SUBJECT: Letter RFQ Solicitation Number - SPRTA1-26-R-0330

This is an USAF requirement. Purchase Request (PR) FD2030-26-00883 is in support of the B-52 aircraft.

1. ENGINEERING ORDER NO. 2011C0941-T

2. DWG TITLE	3. DWG CAGE CODE	4. DWG NO.
Controller, Temperature ACS/MCS	73030	776323

ENGINEERING ORDER *(Continuation Sheet)*		1. ENGINEERING ORDER NO. 2011C0941-T	
		DATE: 20110715	PAGE 2 OF 3 PAGES
2. DWG TITLE Controller, Temperature ACS/MCS	3. DWG CAGE CODE 73030	4. DWG NO. 776323

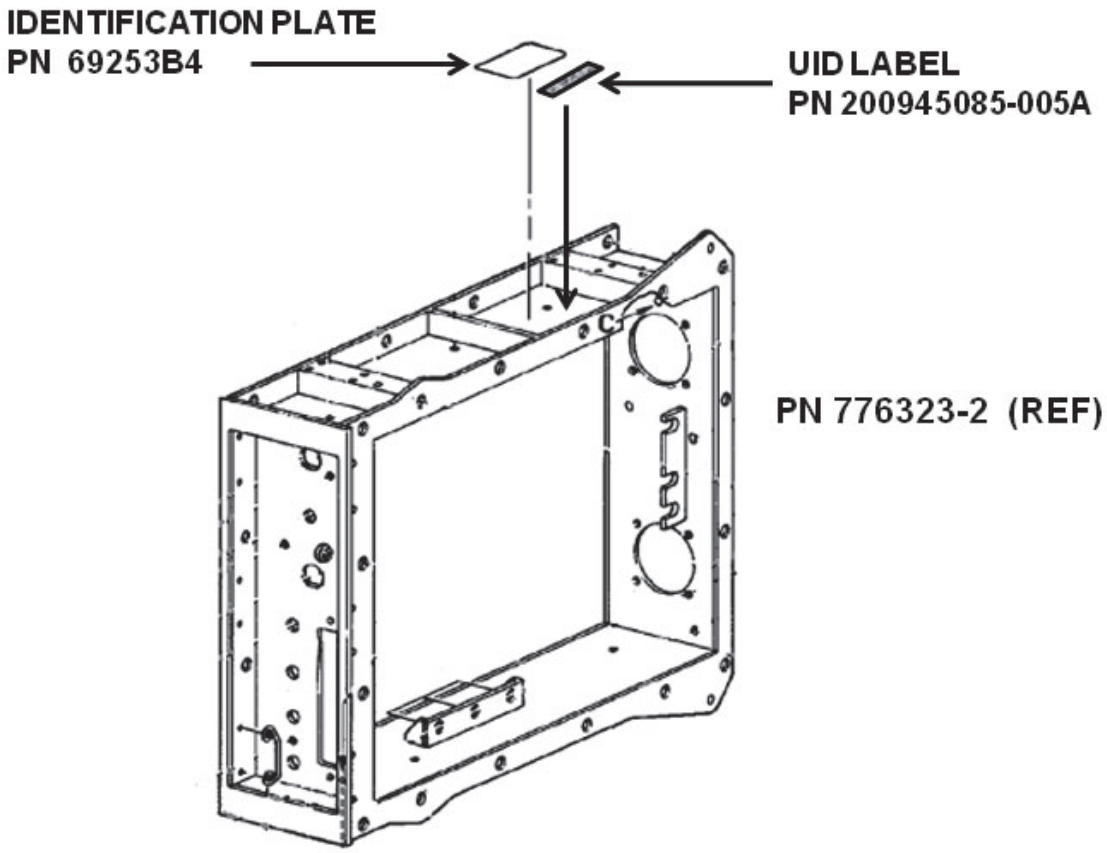
- B-52 Aircraft ACS/MCS Temperature Controller (PN 776323-2) shall be marked with a Unique Item Identifier (UII). (REF: MIL-STD-130)

- If no UII matrix is present, fabricate new identification plate (200945085-005A) and attach to the end item, adjacent to the existing identification plate/label (69253B4).

- The new UID identification plate will be located on the end item as shown in sketch/photo on page 2, AF form 3926.
